ADDENDUM NO. THREE (3)

IFB NO. 2024-282

CONSTRUCTION, EMERGENCY GENERATOR FUELING SYSTEM REPLACEMENT

DATE: JUNE 17, 2024

HOUSING CLUSTER GENERATOR FUELING SYSTEM 2
COLLIN COUNTY JUSTICE CENTER
EMERGENCY GENERATOR FUELING SYSTEMS
4300 COMMUNITY AVENUE
MCKINNEY, TEXAS 75071

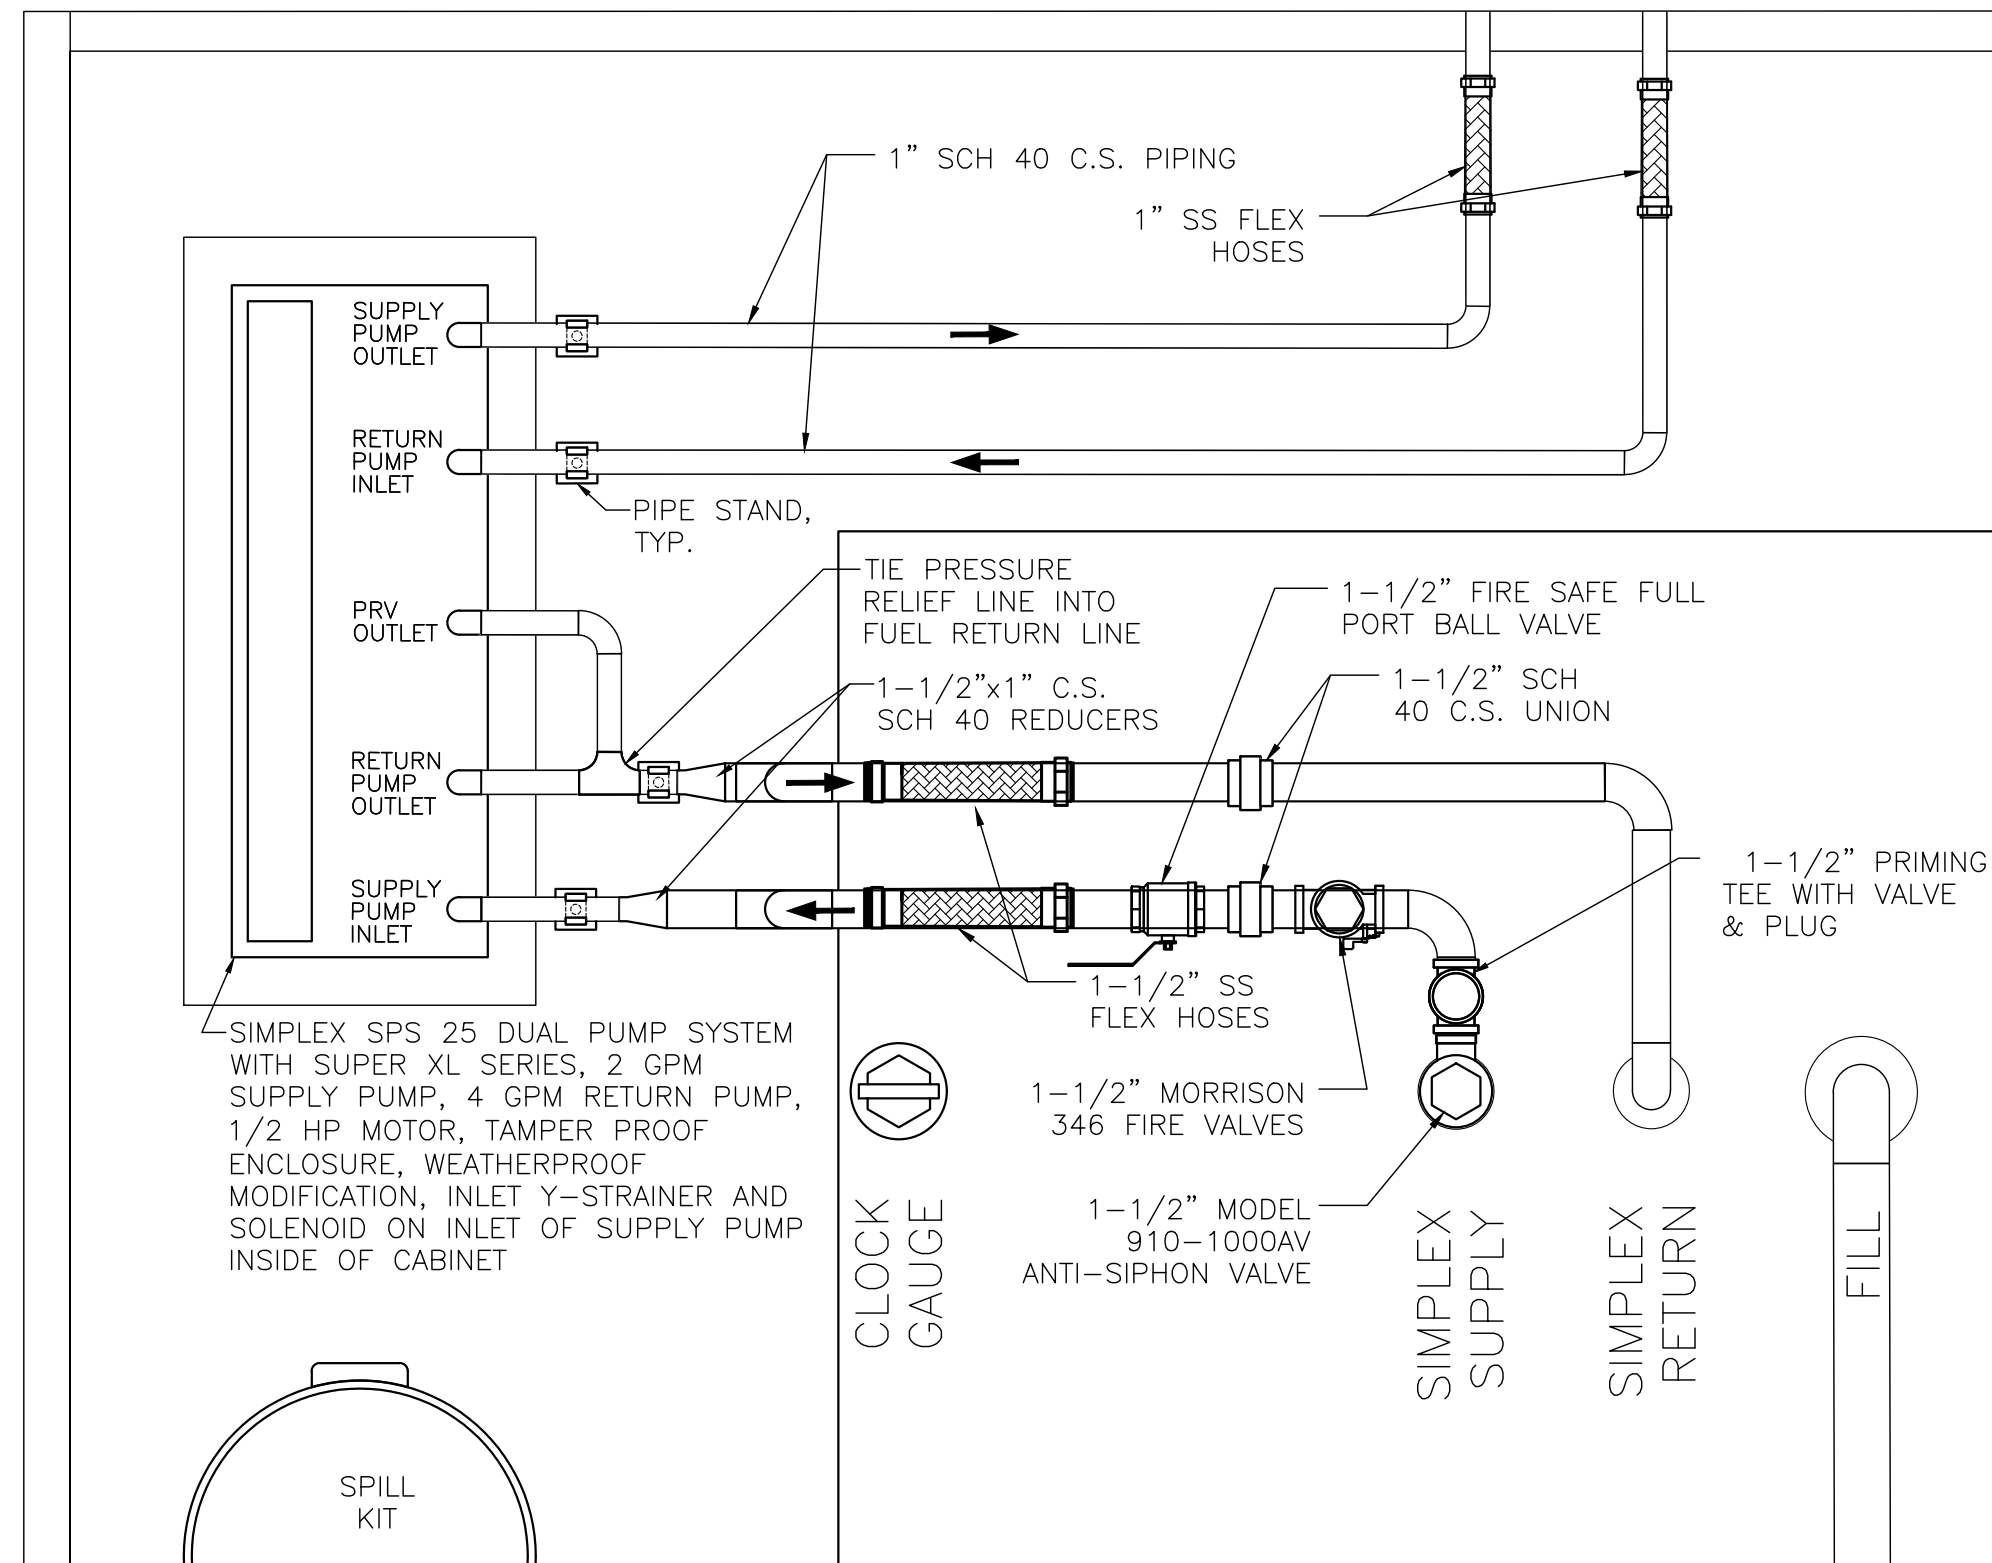
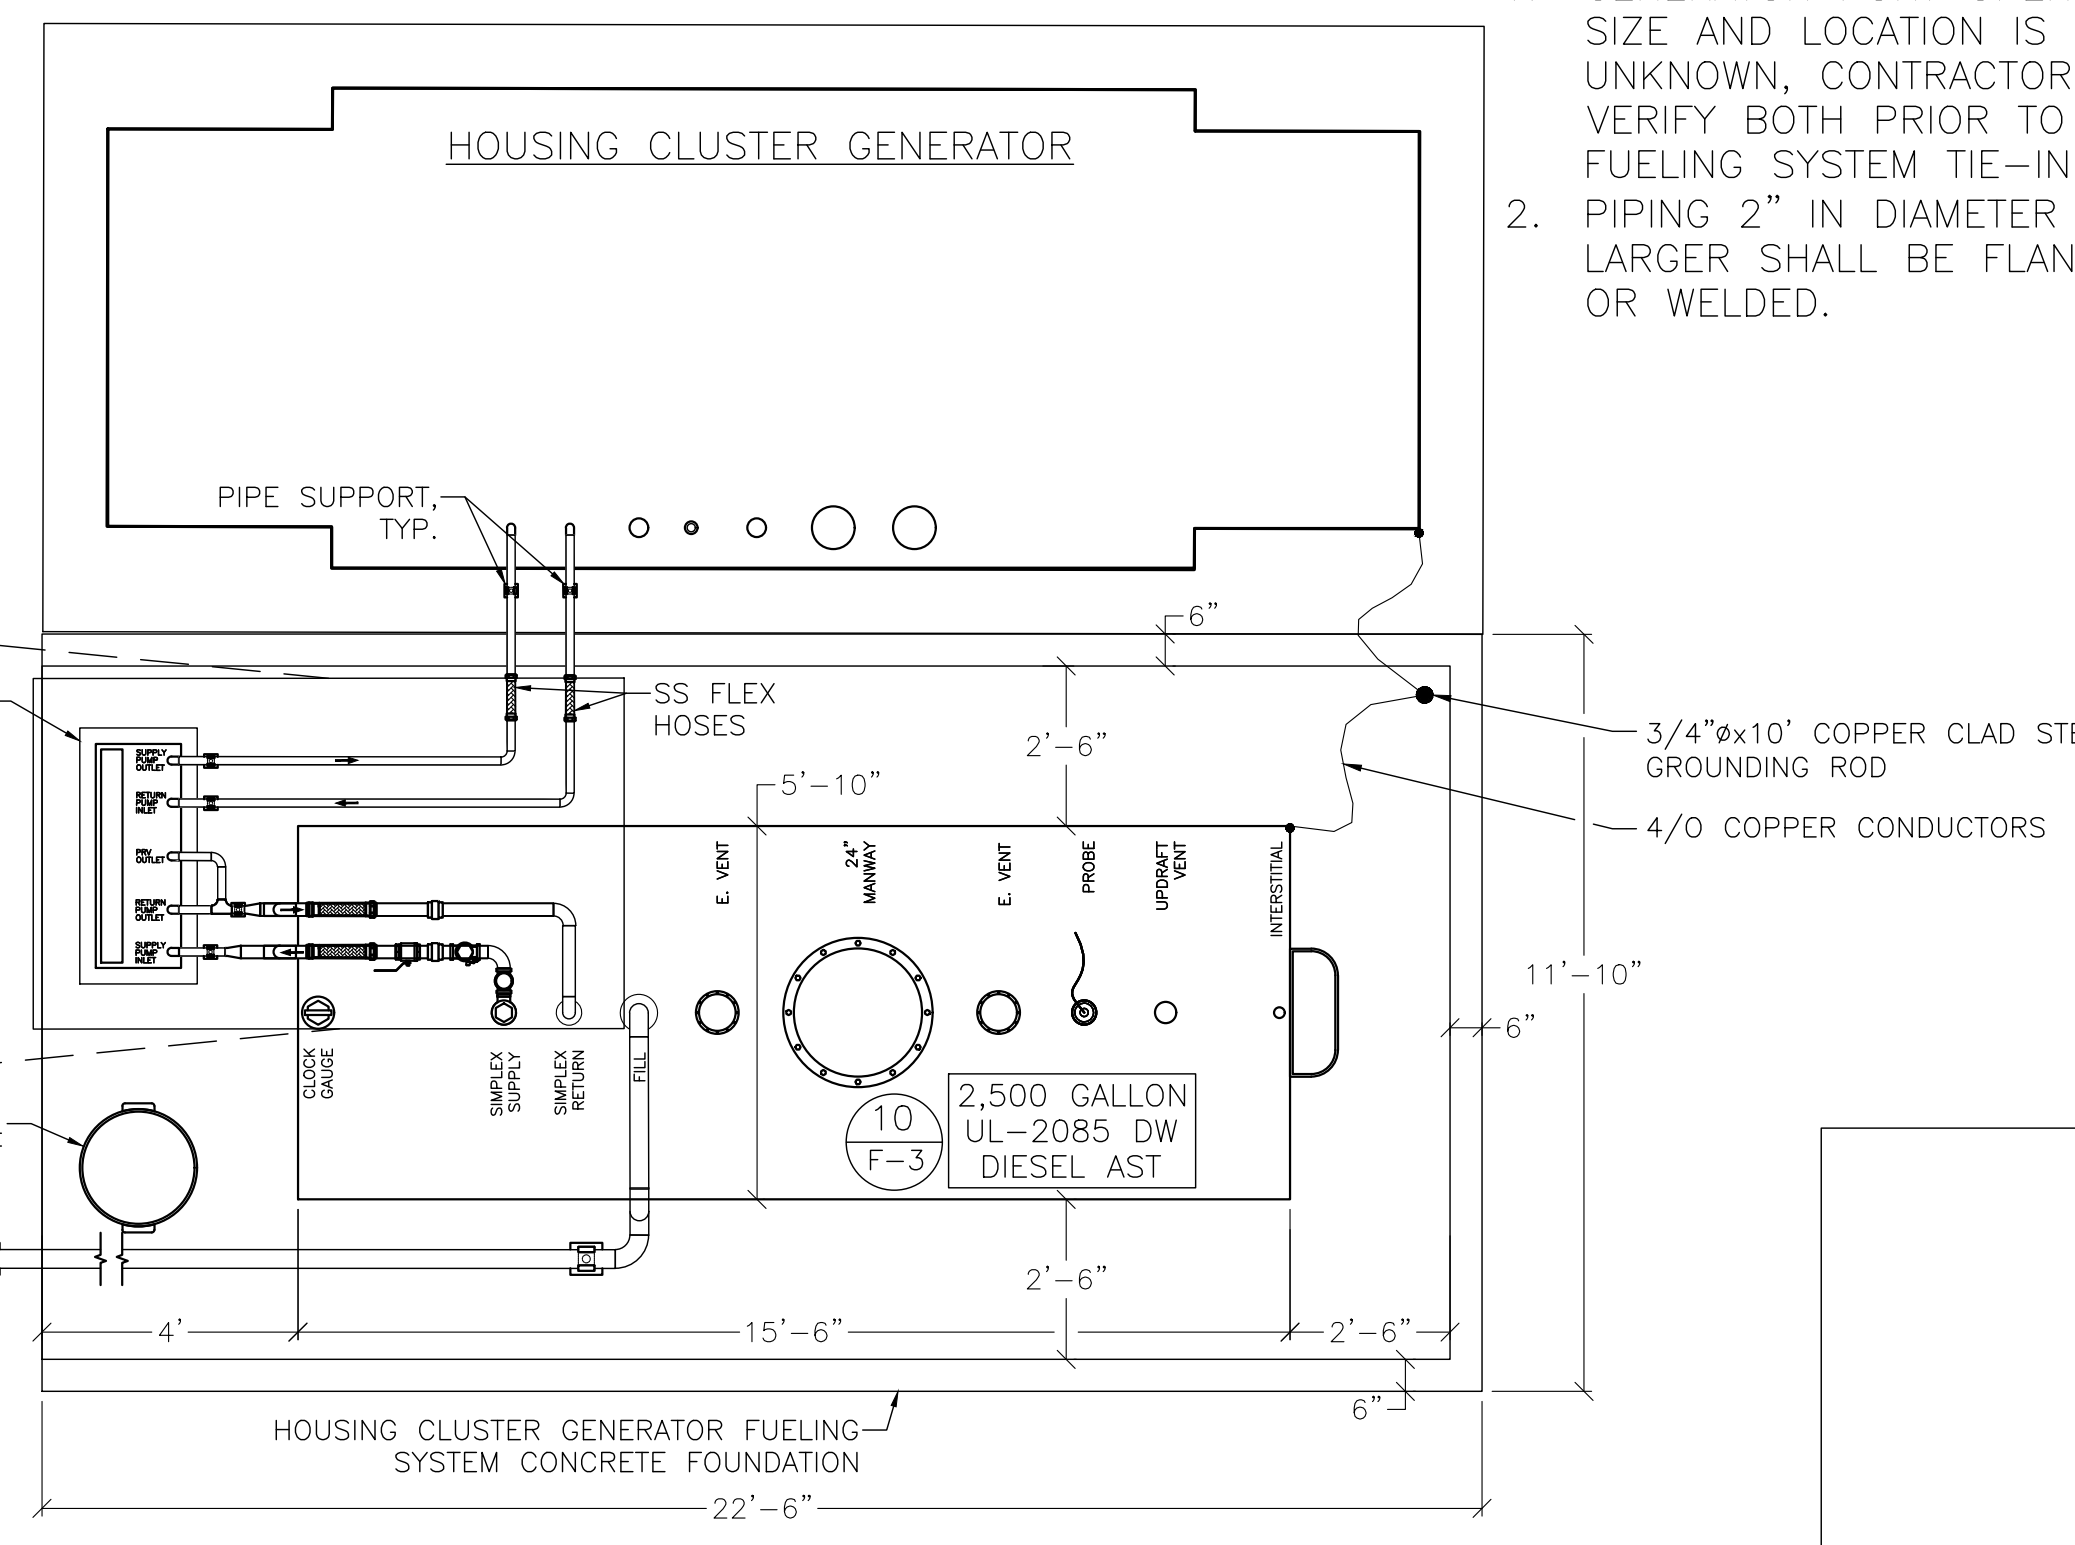
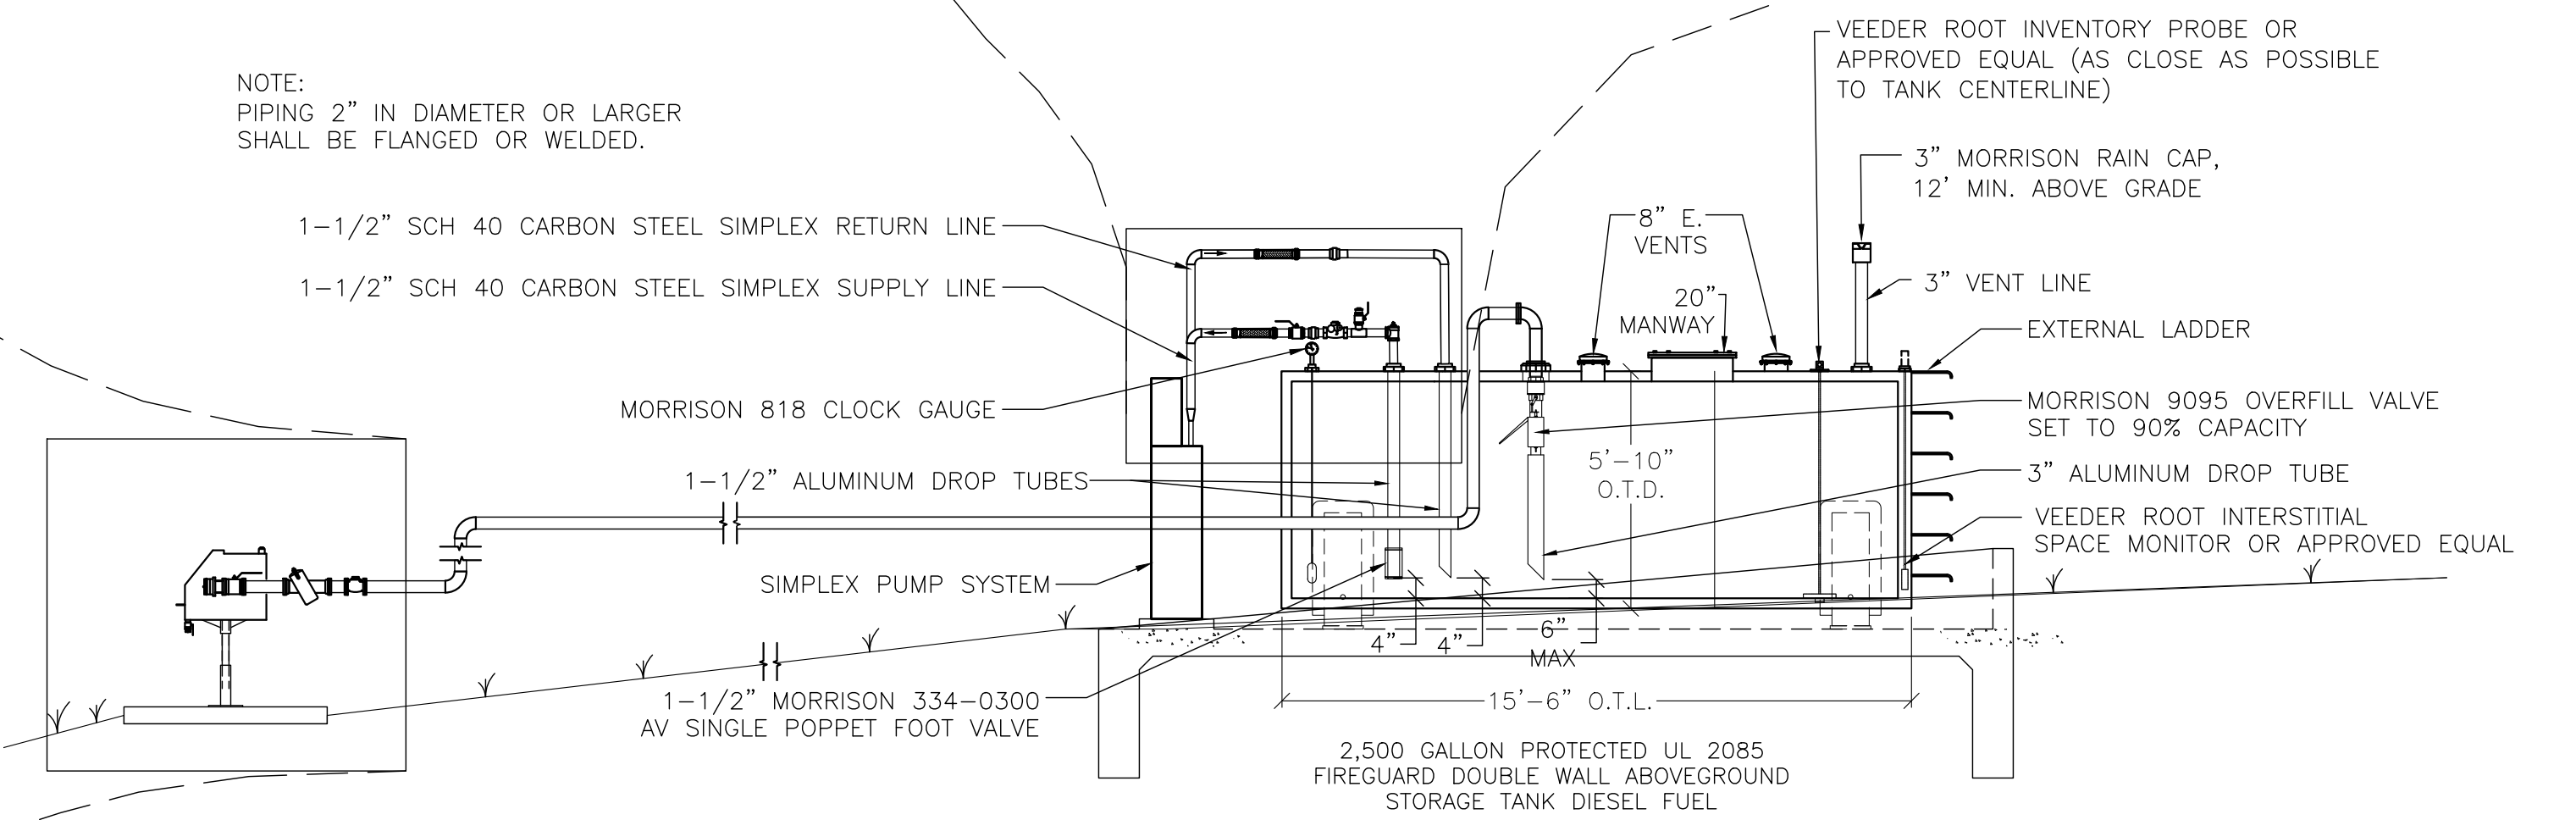
NO	DATE	VALVE CHANGES, PRIMING TEE ADDED, DETAIL ADDED	CDsm BY
1	2024-6-5	VALVE CHANGES, PRIMING TEE ADDED, DETAIL ADDED	CDsm
		REVISION	BY

Question: Drawing 7 of 16, Detail 10/F-3, shows a Morrison 334-0300 on the supply line of each 2.5K tank. Drawings 6 of 16 does not show this valve in the same supply line. Is there supposed to be one on each 3K tank as well?

Answer: There should be a foot valve and a priming tee on all supply lines. See Addendum 3 for revised drawings.
